ERRATA

August 1, 2025

AUBoard-15P Development Kit – Revision 1

Incorrect Value on PCIe AC Coupling Capacitors

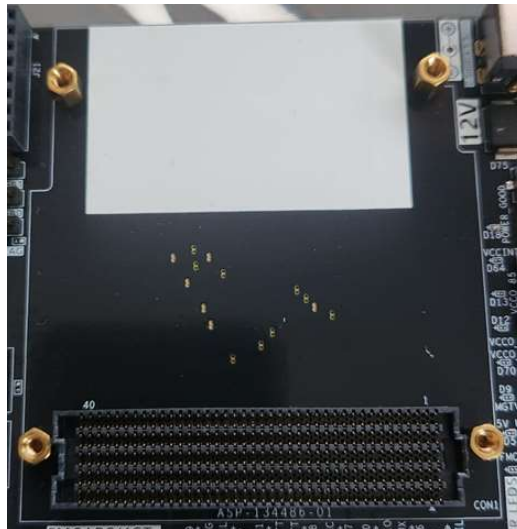
Description – It has been determined that the incorrect AC coupling capacitor value has been populated on the data lanes of the PCIe interface. 100nF AC coupling was populated on the boards when a value such as 220nF is more in line with PCIe specifications when supporting PCIe Gen 3 or Gen 4 data rates.

During our testing, the 100nF coupling didn't not show an overall effect during operation.

Workaround – While we have not seen erroneous behaviour with the capacitors populated on the board, it does not mean that the 100nF solution will work in all cases as it is not possible to validate all mating platforms. The only available option here would be to replace the data lane 100nF capacitors with suitable 220nF capacitors.

AUBoard-15 FMC Add-On Location

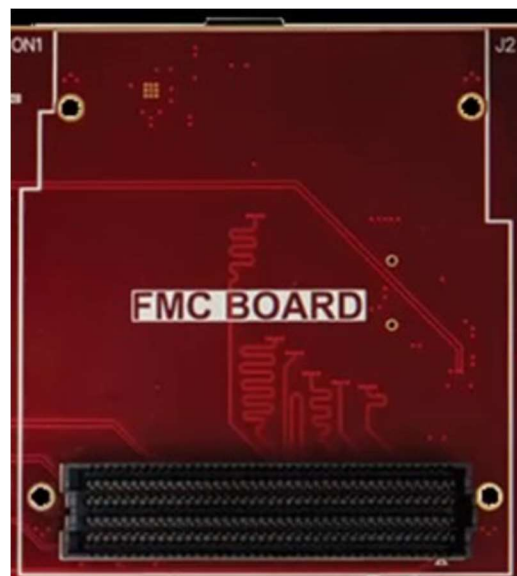
Description – It has been determined that the silkscreen and the top mounting holes for the FMC add-on card location were accidentally inverted. The images below show the AUBoard-15P and a comparison to a platform with the appropriate silkscreen and top mounting holes.

Workaround – The AUBoard-15P top mounting hole alignment is skewed. A potential solution for mounting may be to make use of smaller hardware components to provide flexibility to mount with. Aside from this, the misalignment and silkscreens will be corrected in Revision 2 of the AUBoard-15P.
